Subject: Response to Transport Comments on Drury
Metropolitan Centre Stage 2 (Fast Track)

Ref: 25001

26 August 2023

This memorandum responds to the key transport issues raised by New Zealand Transport Agency (“**NZTA**”), Auckland Transport (“**AT**”) and Auckland Council’s peer-reviewer (“**AC**”) within the following documents:

Signalized - PT Offset 10% - Background 0% - Drury (40%)

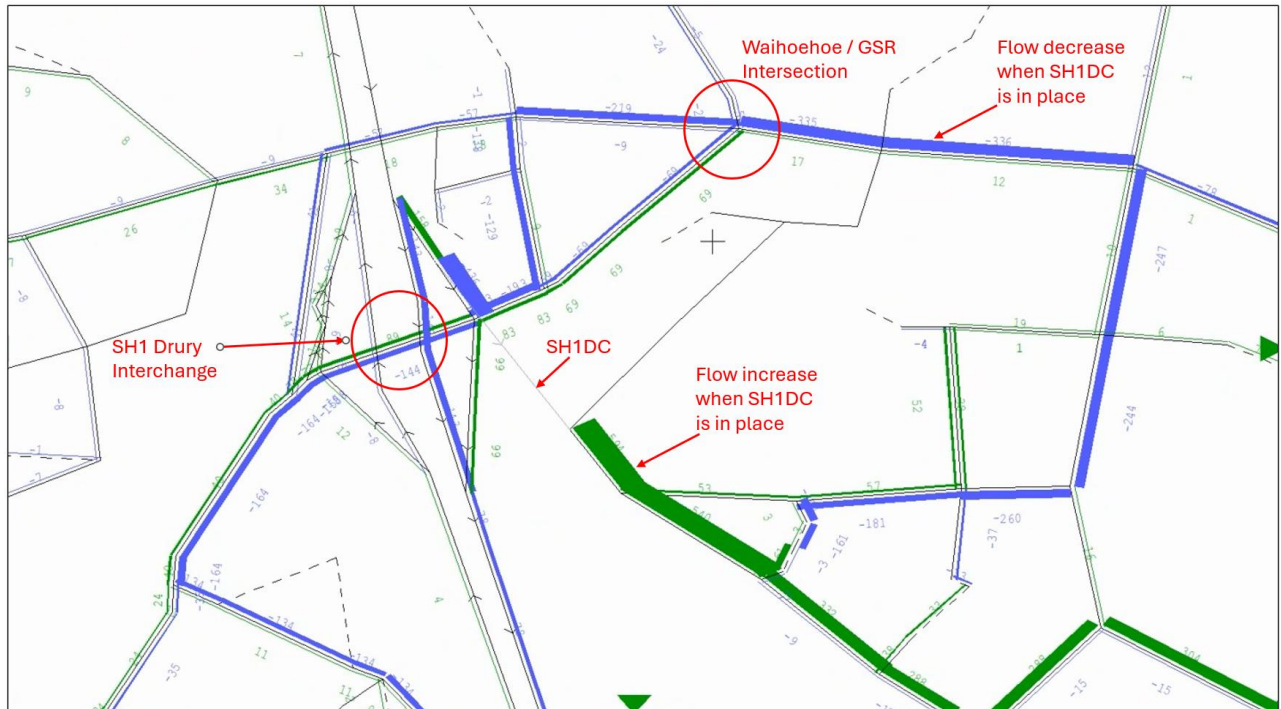
For the subject consent, traffic modelling was also carried out – prior to any adjustments to account for WFH effects or changes to development mix being made – to assess the effect of recent changes to the timing of proposed infrastructure upgrades, being the delay to the SH1 six-laning upgrade and the early implementation of the Ultimate Waihoehoe Upgrade.

As discussed within Section 5.3 of the ITA, this traffic modelling established a new threshold of 2,000vph for the network once the Ultimate Waihoehoe Road Upgrade is in place, but without the SH1 six-laning or the SH1DC, and the Sidra output for that test was provided as Appendix A to the ITA. To add further context to these results, the PM Sidra output is provided below, with some notes to explain the inputs and outputs.

- The green circle shows the average queue length on Waihoehoe Road as 241m, which is within the 245m threshold to the Kath Henry Lane / Rail Station intersection, as per the required network capacity criteria. This represents a "pass" condition to the test.

- The red circles show the incoming traffic flows into Drury East from the south, north and west approaches to the intersection. Because the SH1DC is not in place in this scenario, some of the incoming traffic that it would have accommodated diverts onto those three movements, ensuring that all three are greater than would be the case if the SH1DC had been in place.

- It would be logical to assume that the Great South Road southern approach's right turn into Waihoehoe would carry the significant burden of this extra traffic flow, however, as seen in the image below (showing the difference in traffic flows *with* the SH1 direct connection compared to *without*), the Saturn model diverts these trips throughout the network and in all directions, including: a diversion to the west through Firth Street and Norrie Road; to the south via SH1 Ramarama Interchange; and to the west via SH22, GSR (west), Quarry Road and Drury South:

- Accordingly, despite the redistributed traffic flows throughout the network when the SH1DC is not provided, the intersection works satisfactorily and a “pass” condition is achieved, demonstrating that the SH1DC is not required at this threshold stage.
- Also of note, the above image shows that the SH1DC would accommodate approx. 600vph (594 on the image, partially obscured by the green bandwidth line). That equates to approx. 6,000 vehicles per day (vpd), which broadly aligns with AT’s assertion that the SH1DC would carry around 7,000vpd¹. However, AT’s assumption that this traffic flow would instead travel along Great South Road and Waihoehoe Road² is not realised in the modelling. As described above, the Saturn model distributes the traffic flows widely across the model, which minimises the direct effects on Waihoehoe Road.

Saturn output: Difference in delays when SH1DC is added (green=increase; blue=decrease)

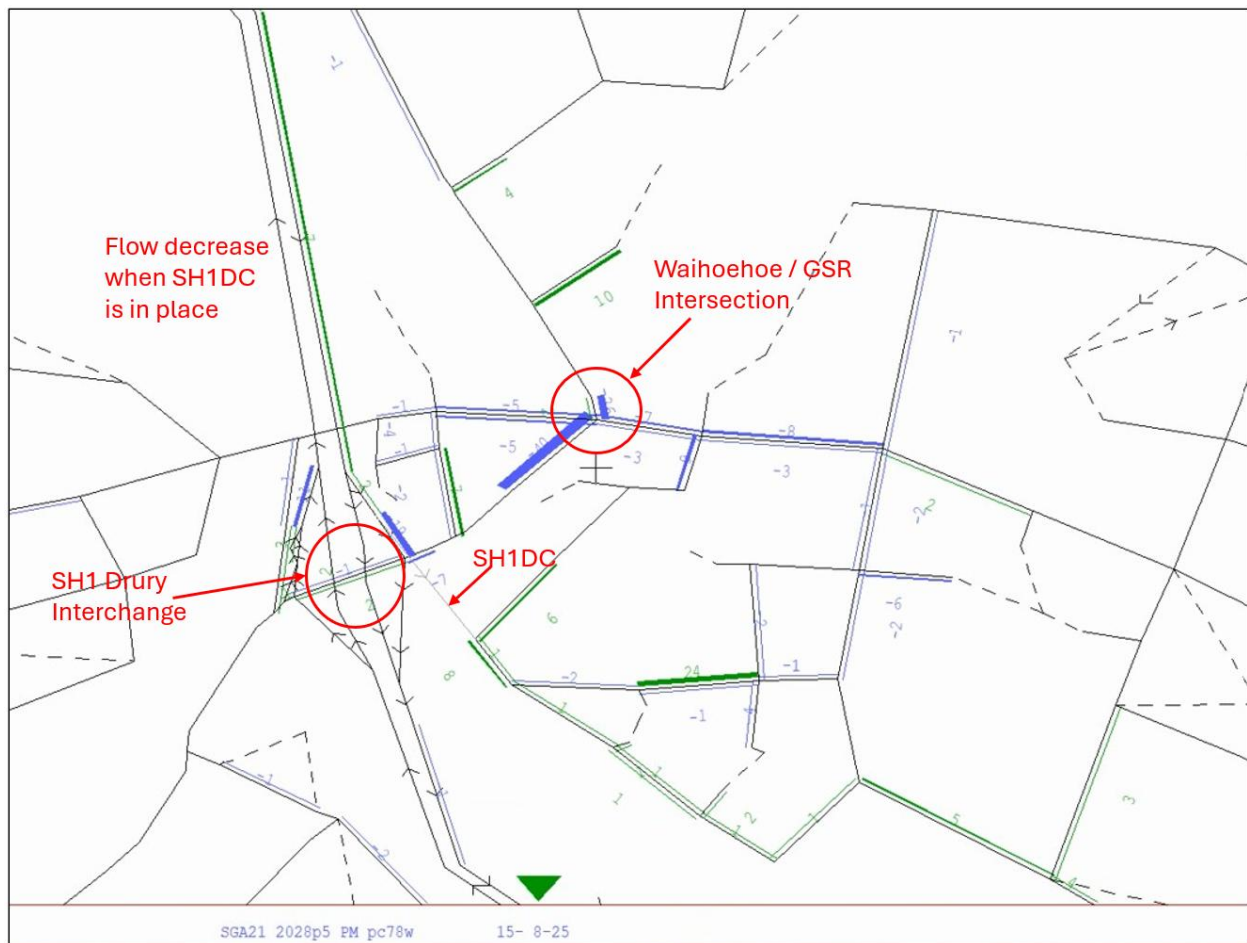
Concerns have also been raised by AT about the performance of other intersections in the network without the SH1DC in place. The below image shows another Saturn output that shows the difference in delays *with* the SH1DC, compared to *without*:

¹ AT memo Para 52: “A table with traffic volumes on roads within and without the Direct Connection indicated it would carry around 7,000 trips per day of southbound traffic from the southern motorway”

² AT memo Para 54: “Circa 7,000 trips per day being redistributed to Great South Road and Waihoehoe Road and respective intersections such as Kath Henry Lane and Fitzgerald Road which would have otherwise been captured by the SH1 off ramp.”

- Most of the relatively minor decreases in delays that the SH1DC enables are at the GSR / Waihoehoe Road intersection, primarily on the southern (northbound) approach. That explains why the previous Saturn “flow difference” image shows the Firth Street, Norrie Road diversion as so attractive, as the model is diverting traffic to avoid the northbound queue to the intersection that is evident without the SH1DC.

- Despite the minor decreases in delay that the SH1DC supports, the intersection still performs adequately without it, as demonstrated in the Sidra output provided earlier. One reason for this is that the changes to delays are relatively minor, and also that the additional incoming traffic flows (shown in the red circles on the Sidra output image above) are not travelling in the critical direction for the PM peak – i.e., westbound along Waihoehoe Road, exiting Drury East.

- As expected, there are no significant additional delays observed anywhere else in the surrounding network.

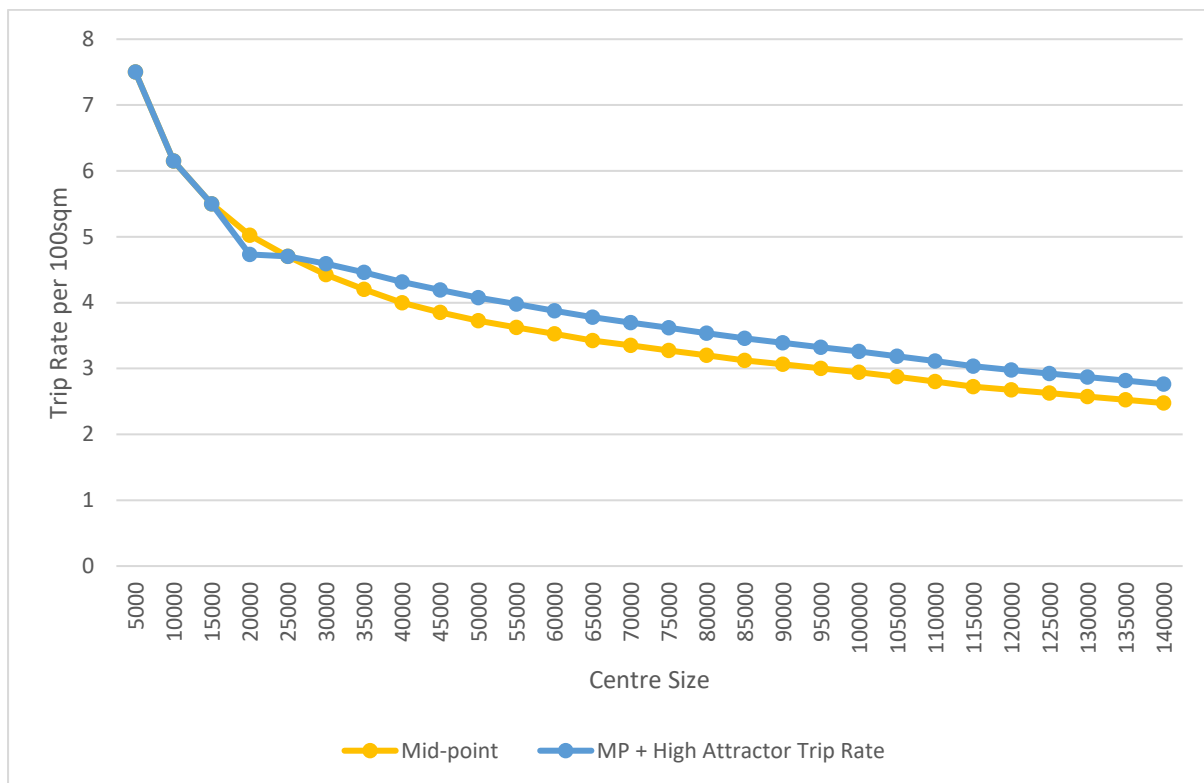
AT and NZTA have concerns that a potential “high trip attractor” retail tenant would affect trip rates and resulting trigger thresholds

- **AT memo:** paras 37–41 (variability for LFR and potential weekend/PM impacts), para 55 (risk of high-attractor retail drawing wider catchment beyond standard rates).

The below graph shows the SGA shopping centre trip rates (the mid-point between Sylvia Park and ITE rates) in orange, and the changed trip rates that the assumed 18,000sqm GFA high-attractor would bring in blue:

This demonstrates that a high attractor has already been taken into account within the trip rate calculations within the ITA and the subsequent 21 July memo, which in turn has raised overall retail trip rates and therefore restrained the amount of other retail that could be accommodated at each of the trigger thresholds (remembering that the trip generation thresholds for each row remain fixed to maintain the integrity of the modelling results).

Flanagan Road / Road 3 Proposed Roundabout – Including Bus Tracking

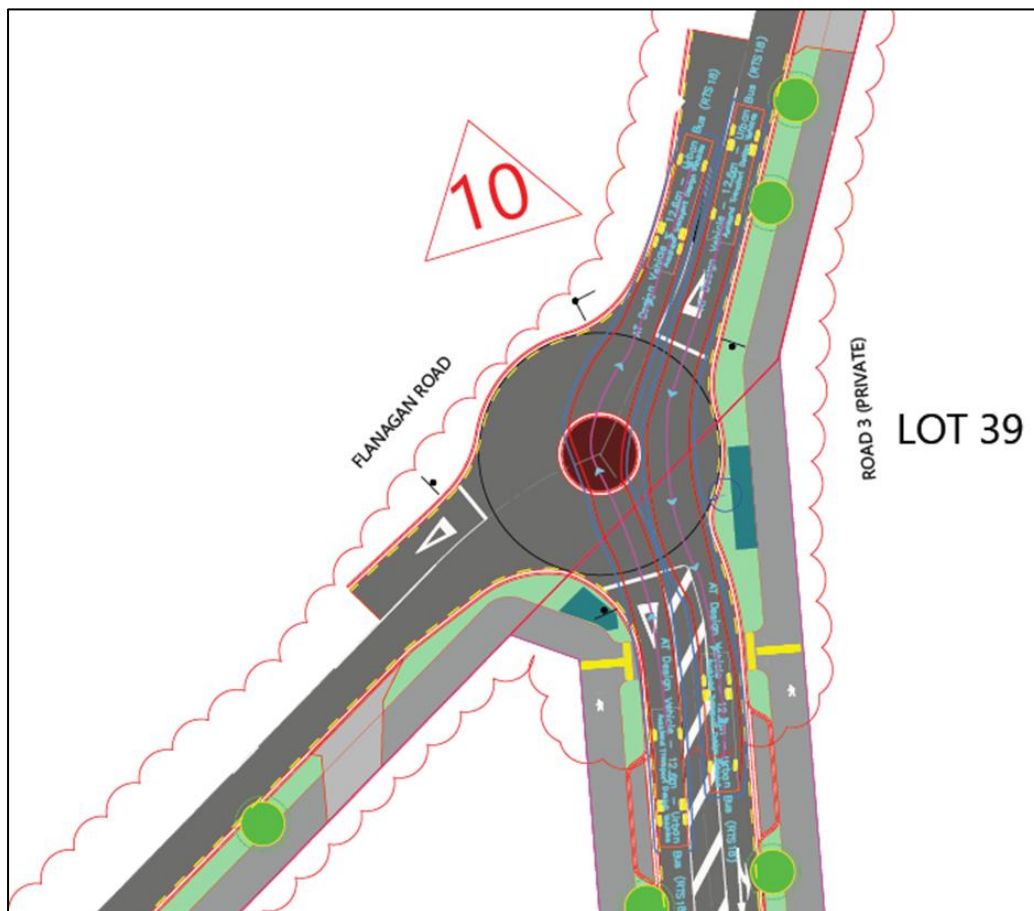
AT and AC prefer retaining many internal roads in private ownership to avoid operational problems.

- **AT memo** – Proposed Private Roads: **paras 78–83** (PT using private roads; need for vesting/continuity). **Paras 90–92** (provide the 25–6–3 bus route early). **Para 88** (coordination so AT/ATOC can accept ownership/operation of signals).
- **AC memo:** “Private traffic signals” (EPA-stage resolution), and explicit requirement for Signals Layout Plans showing integration with ATOC; also “Public access to private roads” concern, noting Roads 3 and 6 are integral to wider PT/active network.

The use of Roads 3 and 6 by buses is an interim arrangement only, until such time as the extension of Road 25 to train station and planned bus interchange are delivered, noting that there is no bus service currently planned and no information as to when it will be developed. Vehicle tracking has been undertaken to confirm that buses can safely and efficiently operate on these routes in the interim, including a redesign of the Road 3 / Flanagan Road roundabout to ensure it can accommodate buses. The revised intersection design including vehicle tracking has been attached to this document, with the image below showing the bus tracking through the intersection.

The proposed private road alignment provides a practical and workable alternative during the staging of the wider network, avoiding unnecessary delays in enabling bus access to the Drury Train Station and the proposed bus interchange

Importantly, Roads 3 and 6 are not the only means of access to the Drury Train Station and proposed bus interchange. In the unlikely event that there is any disruption or restriction to their operation, buses can still access the station via the existing public road network, including Road 25, Road 1, Fitzgerald Road, and Waihoehoe Road. This ensures continuity of service without creating an over-reliance on the interim bus route.

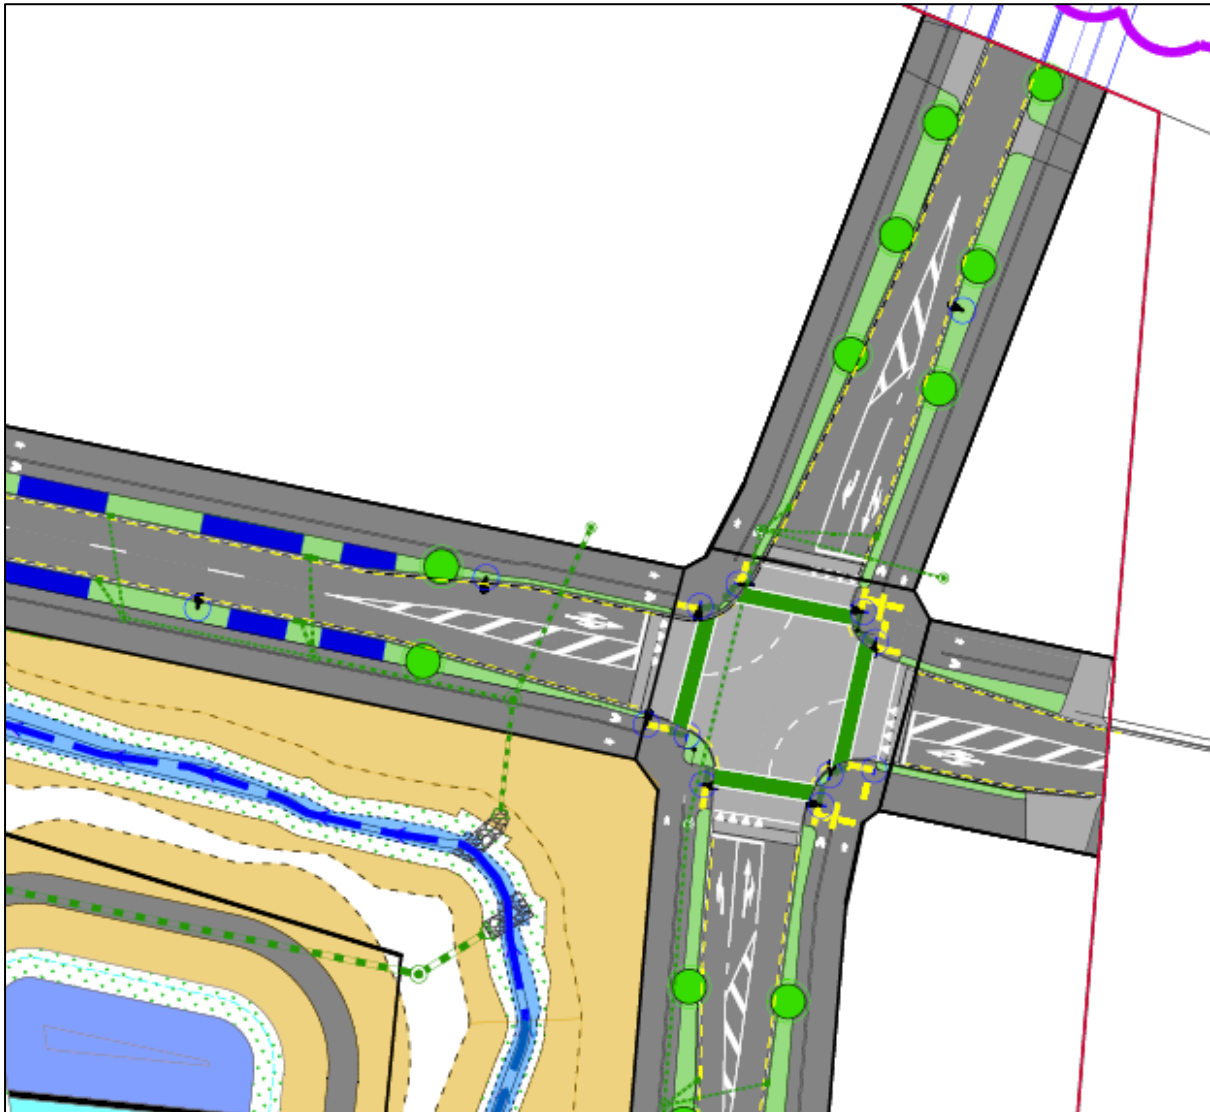
- **AT: paras 96–97** – Road 6 / Road 25 signals layout & operation (incl. 4th leg / active crossing / audit); **paras 94–95, 98–99** – other site driveways / vehicle crossings (widths, mountable kerbs, visibility splays, JOAL conflicts, confirm locations).
- **AC memo: Condition 39(iv)** and related EPA requirements; **RFI table para 35** Private signals integration / ATOC control (applies to Road 6 / Road 25) & intersection layout resolution. **para 89** Driveway design standards & controls (at-grade footpaths, movements, tracking, detailed roading plans): and Condition 39 (intro bullets).

- Crossing width requirements for heavy vehicles and conflict with active modes.
- Road 6/Road25 signalised intersection and access to Lot K.
- Vehicle crossings adjacent to kerbside car parking bays

Two wide vehicle crossings are proposed at the Road 13 access to Lot D and the Road 1 access to Lot A. This is to accommodate the swept path of large vehicles for the purposes of servicing the retail activities. AT has suggested providing mountable kerbs at the Road 13 access to Lot D and the Road 1 access to Lot A in order to reduce the available width for general vehicles. The design speeds within the Stage 2 areas are 30km/h, achieved through narrow lanes and geometry, raised intersections and raised pedestrian crossings. Signage will be provided in support of that speed limit

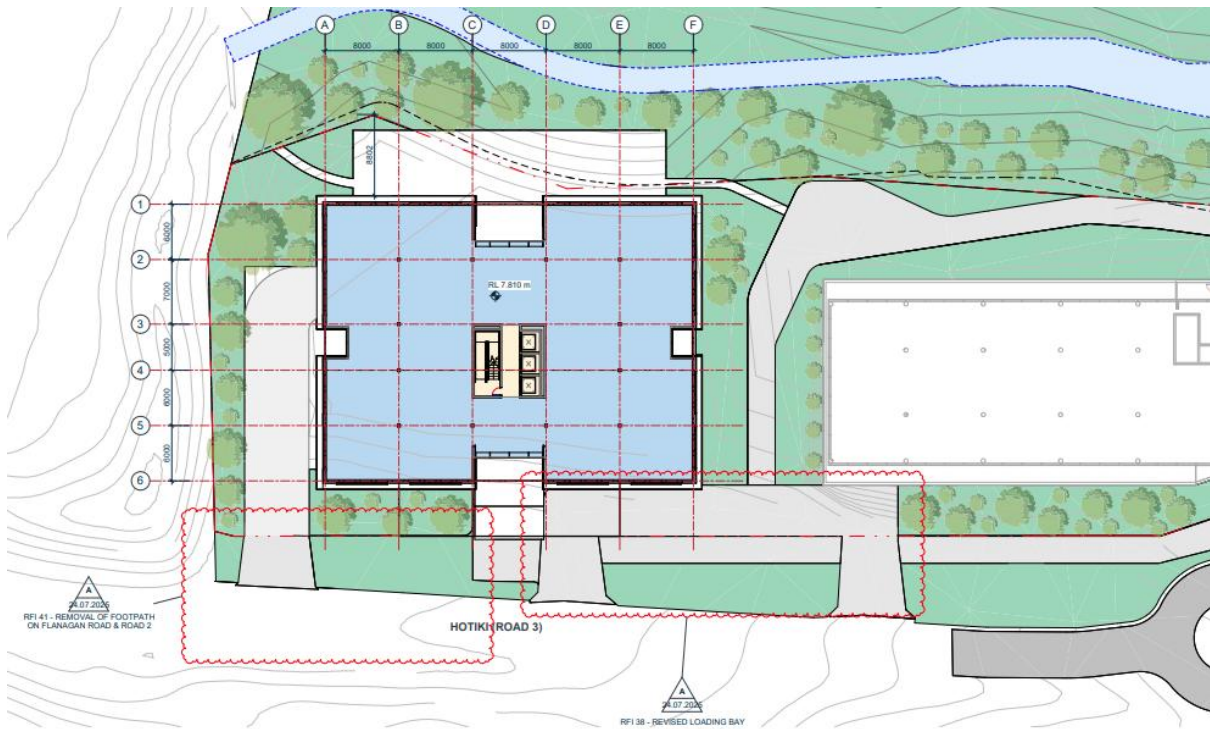
- **AT: paras 100–101** (quantum shortfall; require timed delivery condition outside peak trading and managed by each lot's body-corp).

Building G1 will accommodate the proposed visitor accommodation (hotel), while Building G2 will accommodate the retail and commercial activities within the lot. Three loading spaces are required for Lot G (one per activity type). Two loading spaces are proposed:

- one kerbside space on Road 6, located adjacent to the hotel's main entrance, primarily for guest drop-off/pick-up and service vehicles such as rubbish collection, and
- one dedicated loading space within the G2 car park for the retail and commercial activities.
